## Non-Concurrence Process Record for NCP-2012-004

NCP TRACKING NUMBER  
NCP-2012-004

TITLE OF SUBJECT DOCUMENT NUREG/CR 7130 Assessment of Uncertainties Associated with the BADGER Methodology		ADAMS ACCESSION NO. ML12151A156
DOCUMENT SIGNER Michael Case		SIGNER PHONE NO. (301) 251-7619
TITLE Director	ORGANIZATION RES/DE	
NAME OF NON-CONCURRING INDIVIDUAL(S) Charles Harris		PHONE NO. (301) 251-7637
TITLE Materials Engineer	ORGANIZATION RES/DE/CMB

Draft NUREG/CR 7130 Assessment of Uncertainties Associated with the BADGER Methodology

Figure 1. Irradiated Boraflex. [Refs. 1, 2]. **NOTE:** Disintegrated, eroded, material, holes, delamination, edge scallops (in the right photo). faded color from the original opaque black. {Rulers mark the scale, in addition to a person's feet in the right photo.}

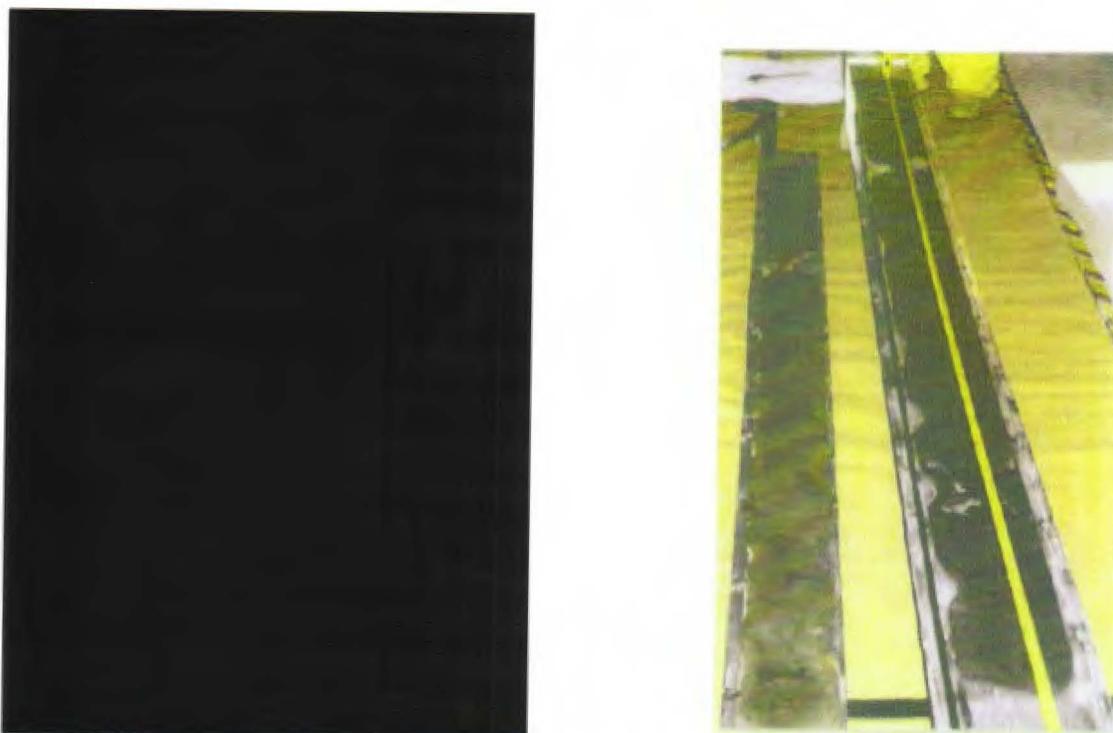
*I think many US power plant licensees can not ensure subcriticality in spent fuel pools because, given the uncertain condition of the neutron absorber materials, such as in Figures 1 through 6 above, I do not believe it is practical for licensees to use their current method (via radiation detectors) of reporting boron-10 content in those materials.*

Once neutron absorber panel degradation begins (up to and including the conditions in the photographs of Figures 1 through 6) then the calibration standards are no longer representative of the unknown materials being measured in the fuel pools.

2. Add as the first paragraph and 5 figures of Chapter 4, "BADGER System Description."

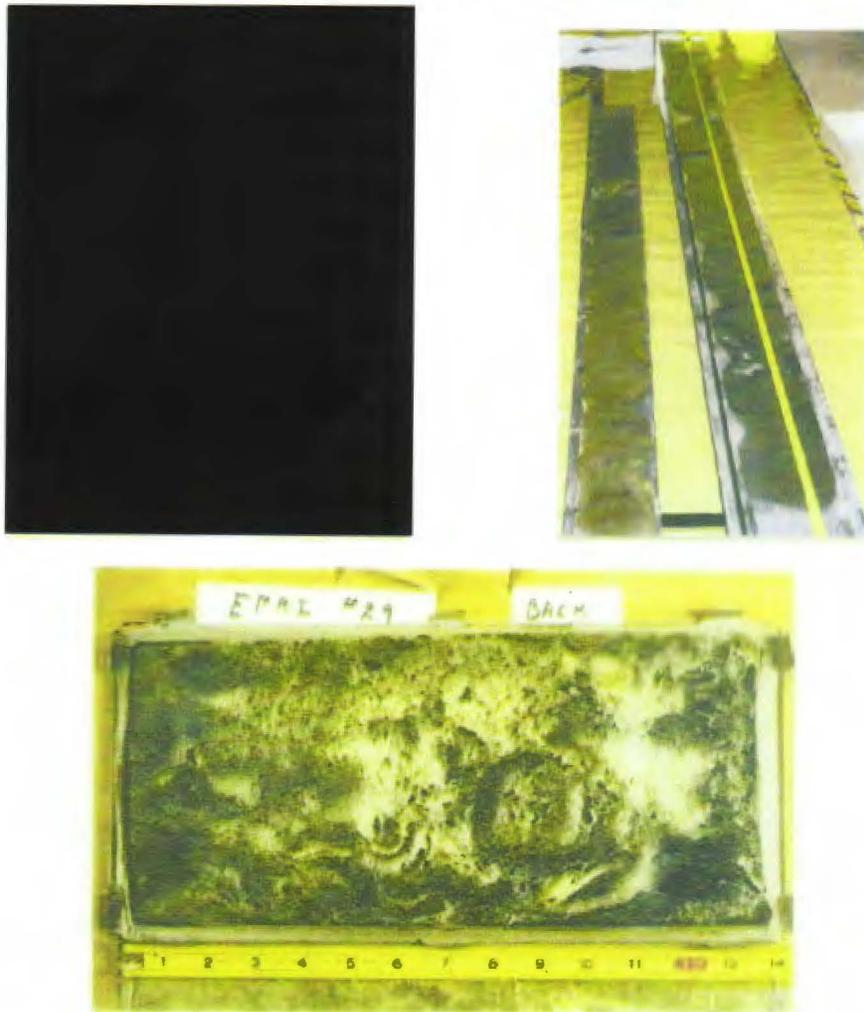
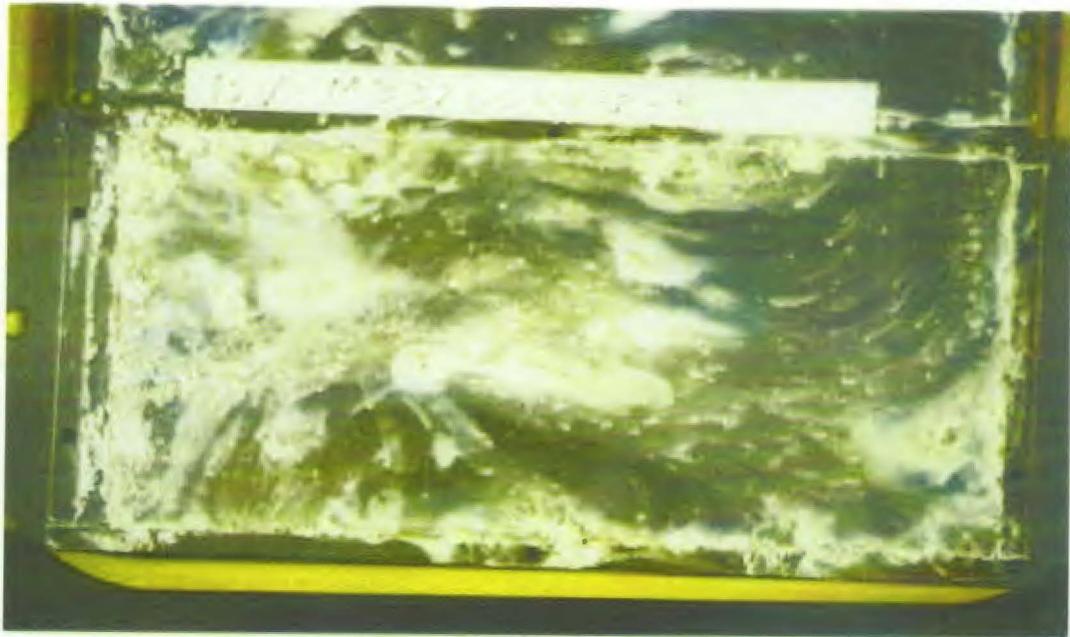
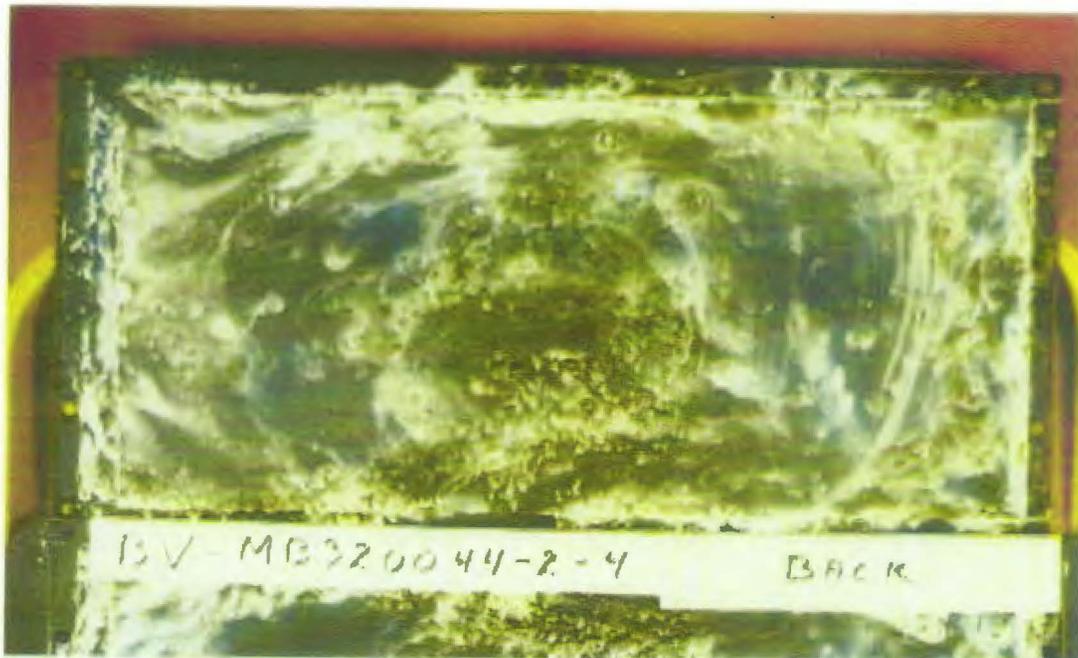
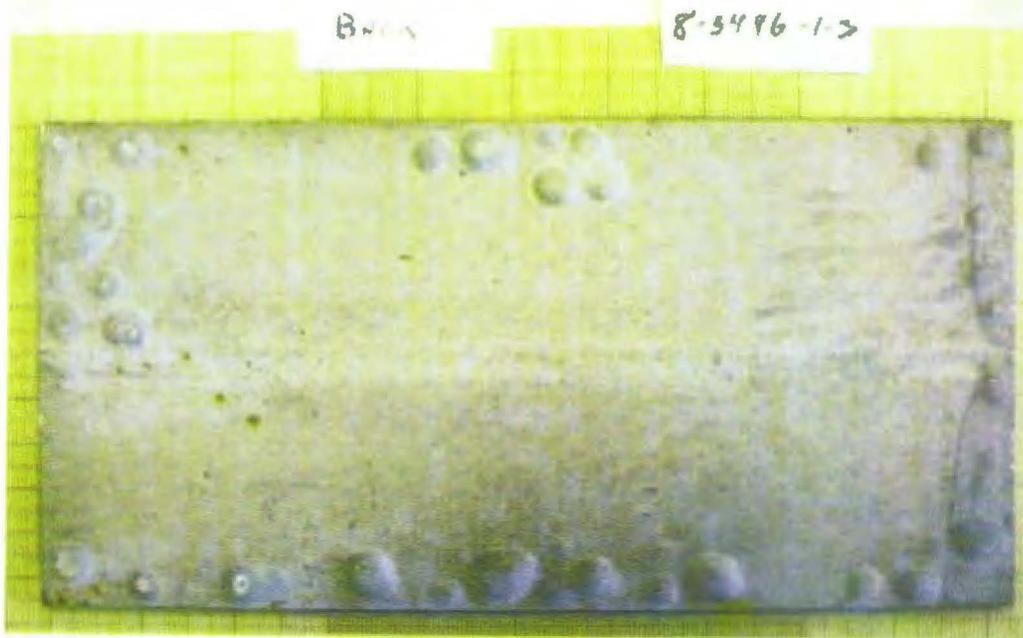
Before describing the BADGER measurement system, it is appropriate to have a sense of the types of material degradations which have necessitated the use of some method to confirm neutron absorber integrity. The following five figures from EPRI documents [ref. 1,2,3, {must adjust reference numbers}] illustrate instances of degraded Boraflex and Boral from spent fuel pools. It is essential to account for any dimensional changes, material losses, corrosion products, or other compositional changes, if BADGER measurements will be employed using calibration curves based on a set of undegraded standards.

Rather than add the pictures to section 5, I propose to add pictures to section 2, which is the background section. I would only add the pictures on the Boraflex material as it is the focus of the discussion.
